ENGINEERING CHANGE PROPOSAL (ECP), PAGE 1 OF 4

SPANNER WRENCH MODIFICATION

13. TITLE OF CHANGE
TUBE HOLDER PAD MODIFICATION

| 13. TITLE OF CHANGE GUNNER'S/COMMANDER'S CONTROL TESTER MODIFICATION | | | | | | | |

8. DOCUMENT NO.
D12311004

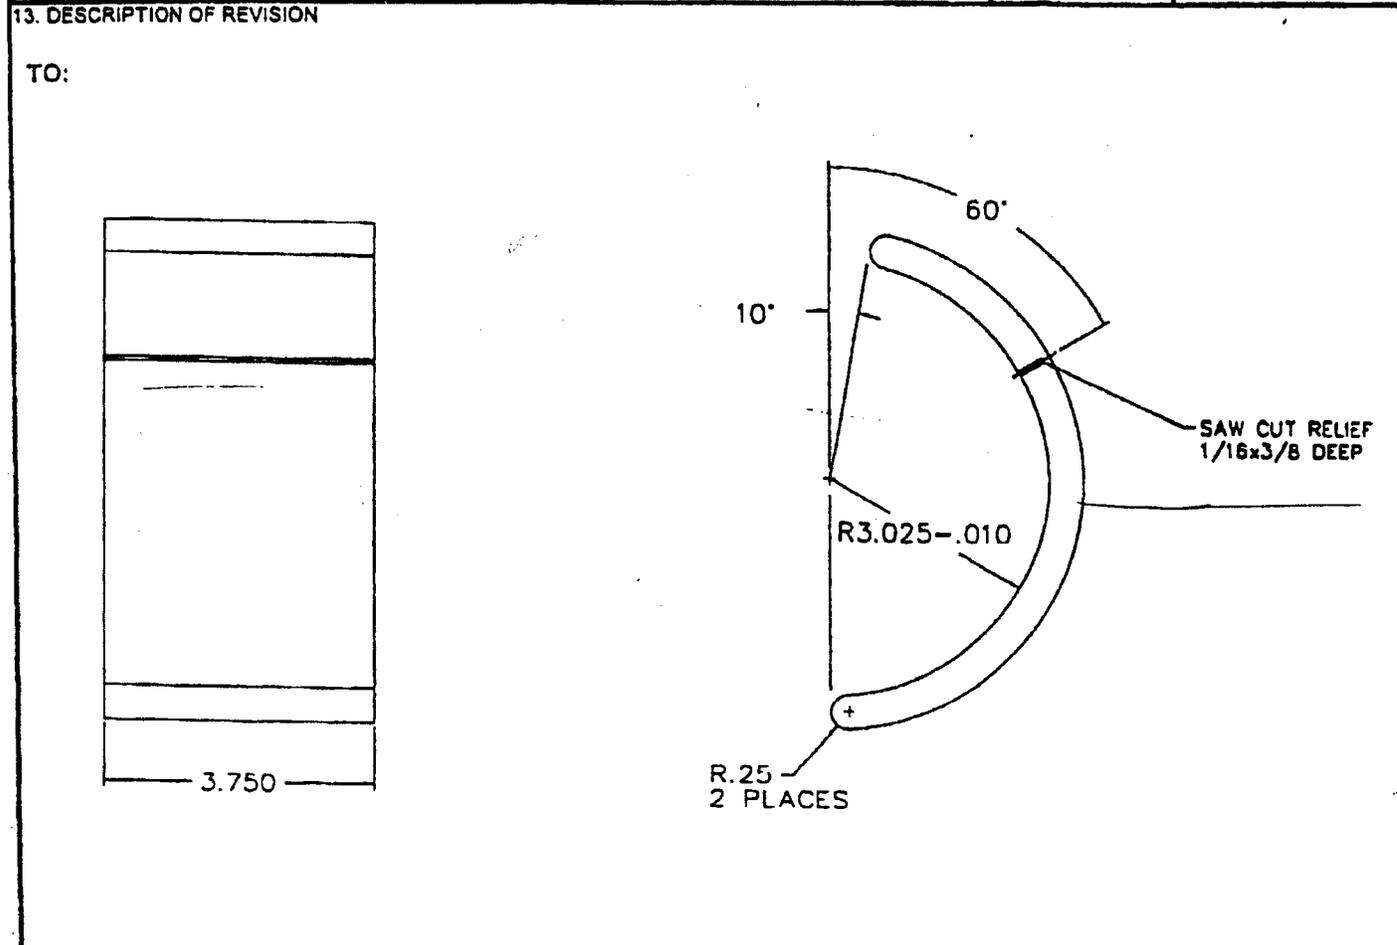
CHANGE DEPICTION OF PAD, FROM:

8. DOCUMENT NO.
 K12311012

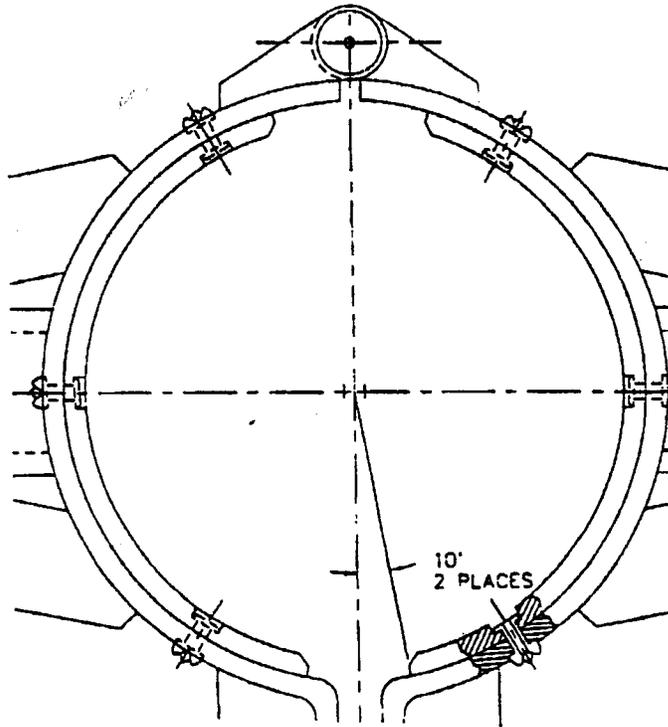
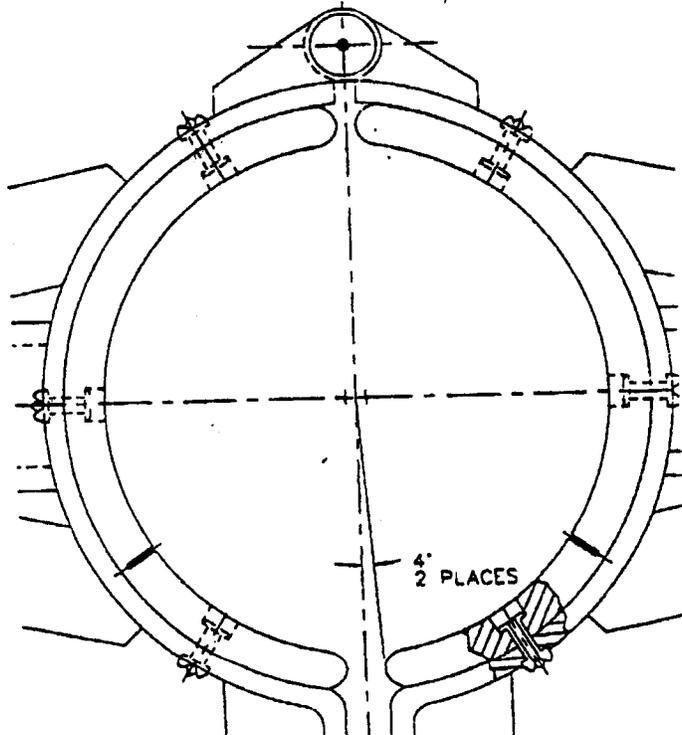
IN ZONES D6, E6 AND F6, CHANGE DEPICTION OF PAD 12311004 AND SPECIFIED ANGLE:

FROM:

TO:
